LANDSCAPE PLAN

11659 BENT GRASS MARKET VIEW
THE LEARNING EXPERIENCE CHILD CARE
FALCON CO, EL PASO COUNTY, CO

HGD COMMENT
RESPONSE: 9-18-26

JOB NUMBER	1348-26
REVISIONS	
ORIGINAL DATE	8-11-26
DRAWN BY	JM
DESCRIPTION	LANDSCAPE PLAN
SHEET NO.	L1.1

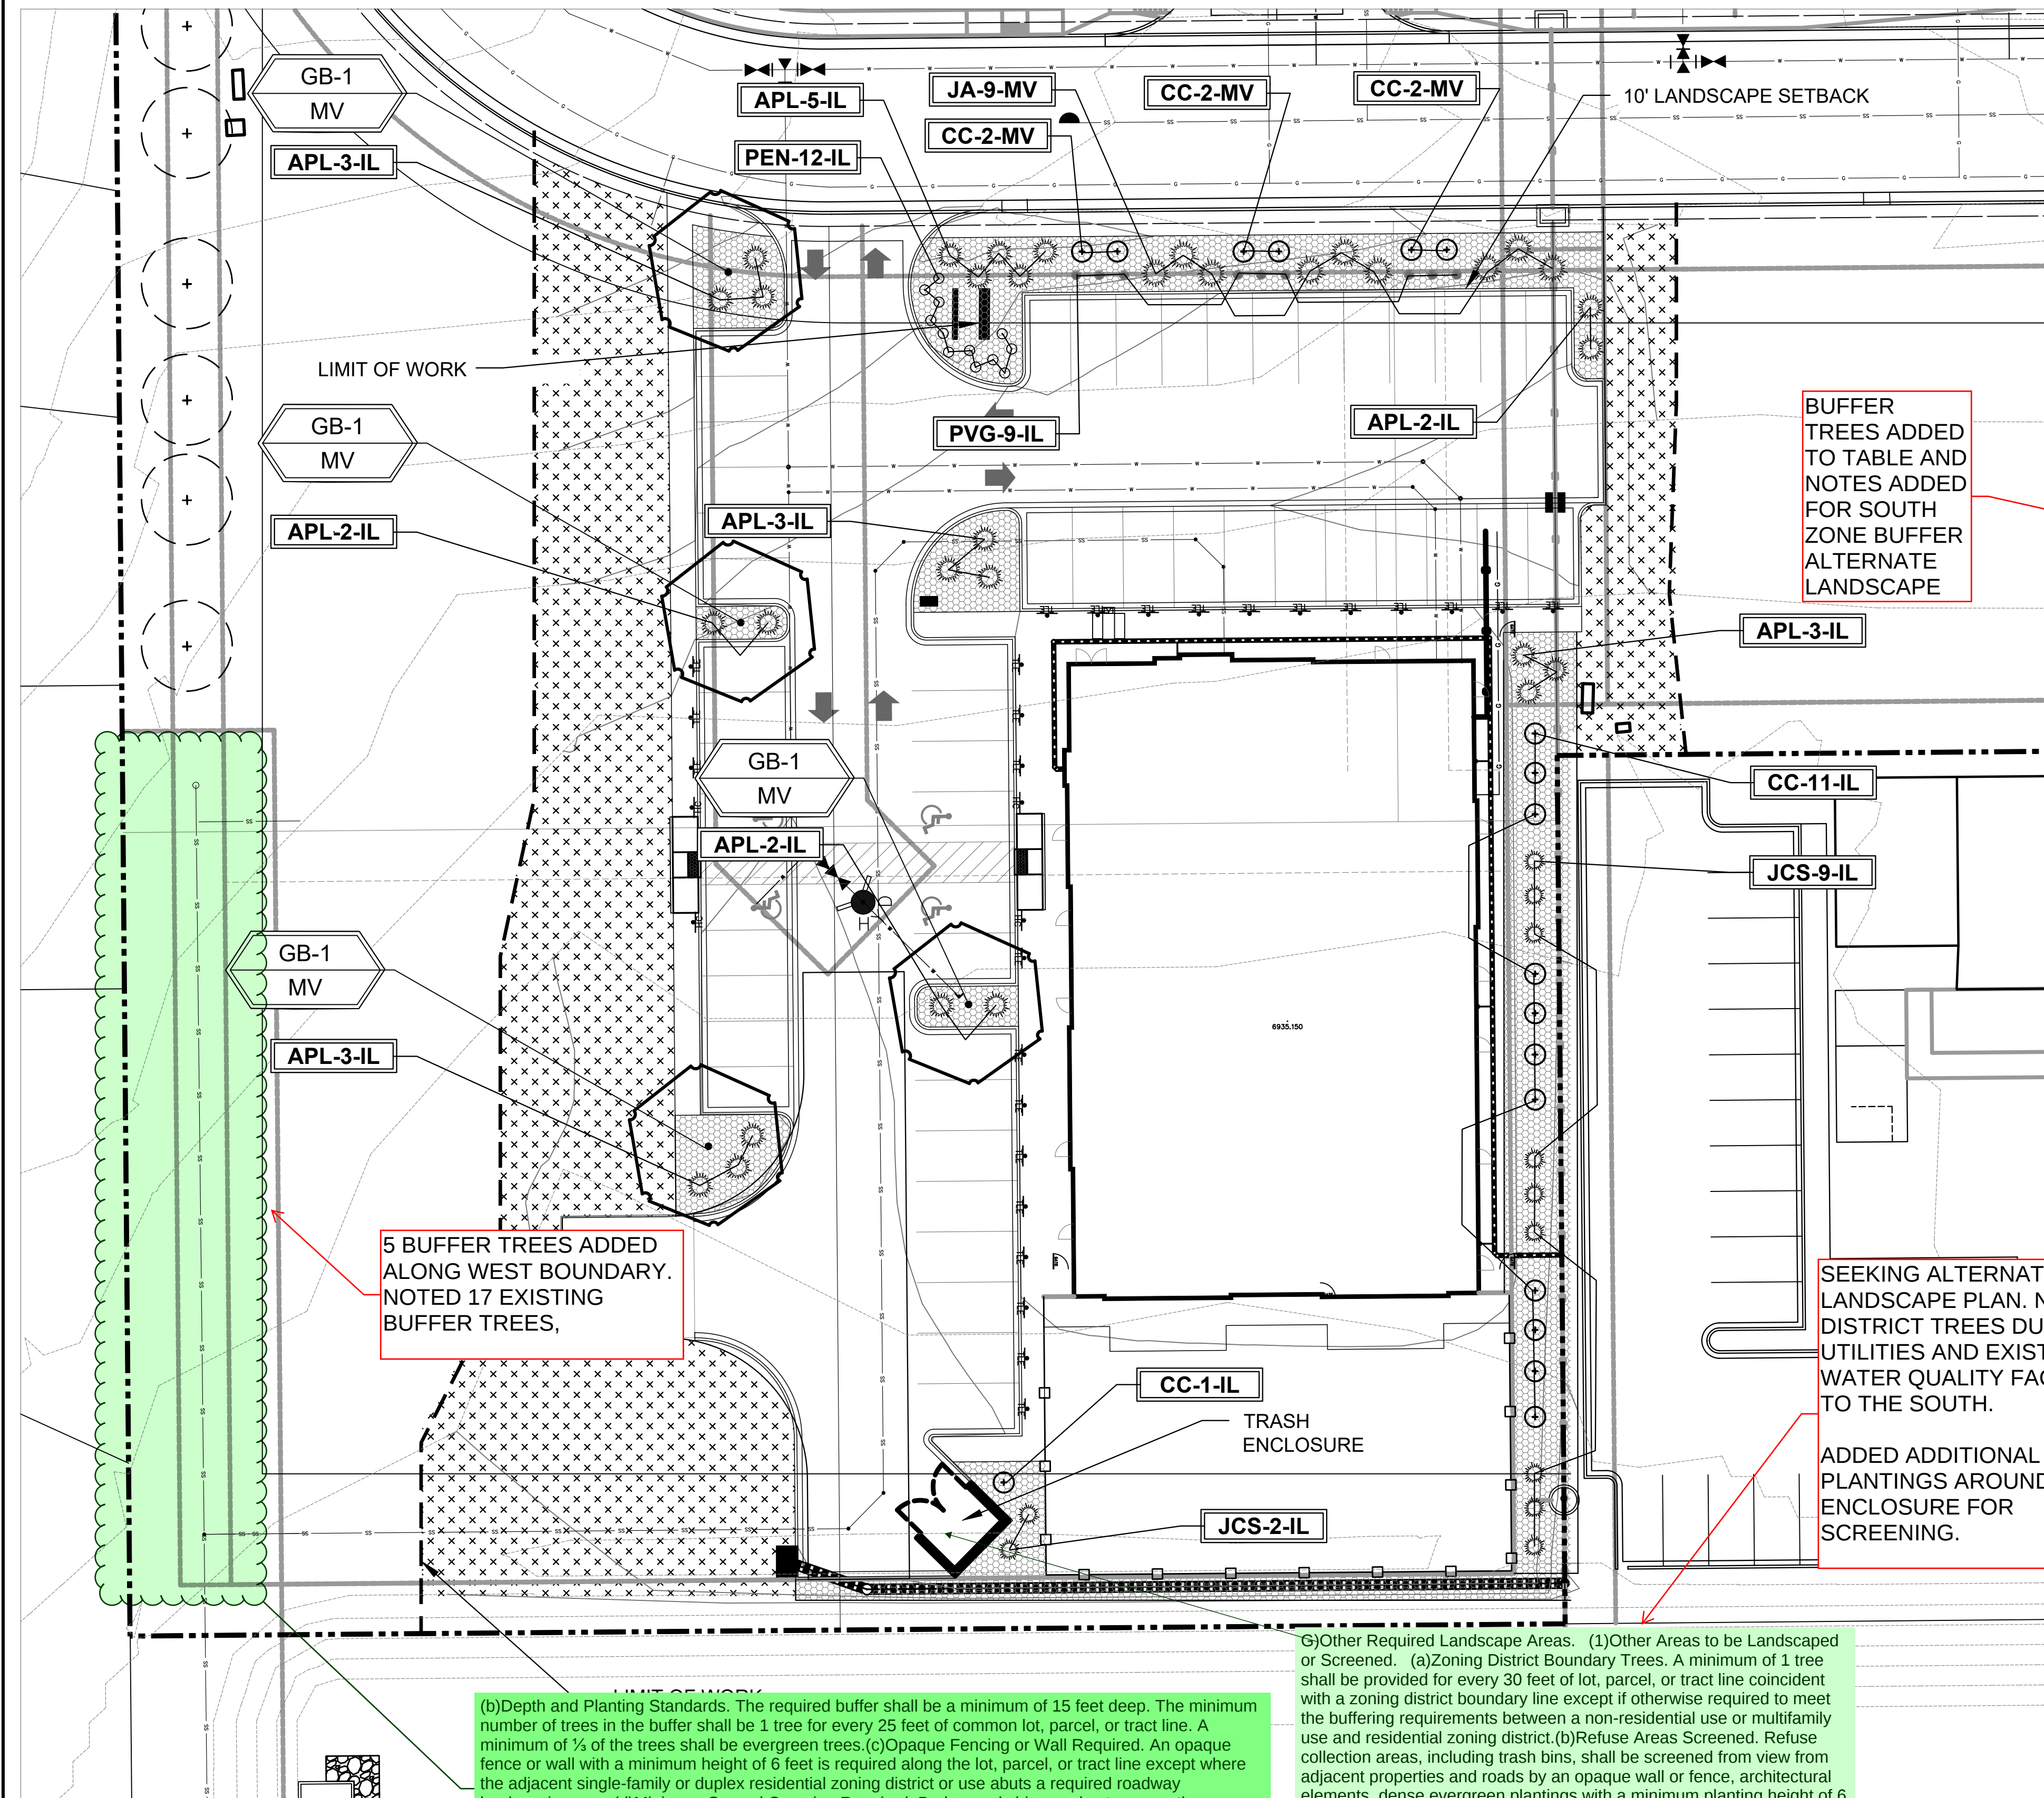
5 BUFFER TREES ADDED ALONG WEST BOUNDARY. NOTED 17 EXISTING BUFFER TREES.

BUFFER TREES ADDED TO TABLE AND NOTES ADDED FOR SOUTH ZONE BUFFER ALTERNATE LANDSCAPE

SEEKING ALTERNATE LANDSCAPE PLAN. NO ZONE DISTRICT TREES DUE TO UTILITIES AND EXISTING WATER QUALITY FACILITY TO THE SOUTH.

ADDED ADDITIONAL PLANTINGS AROUND TRASH ENCLOSURE FOR SCREENING.
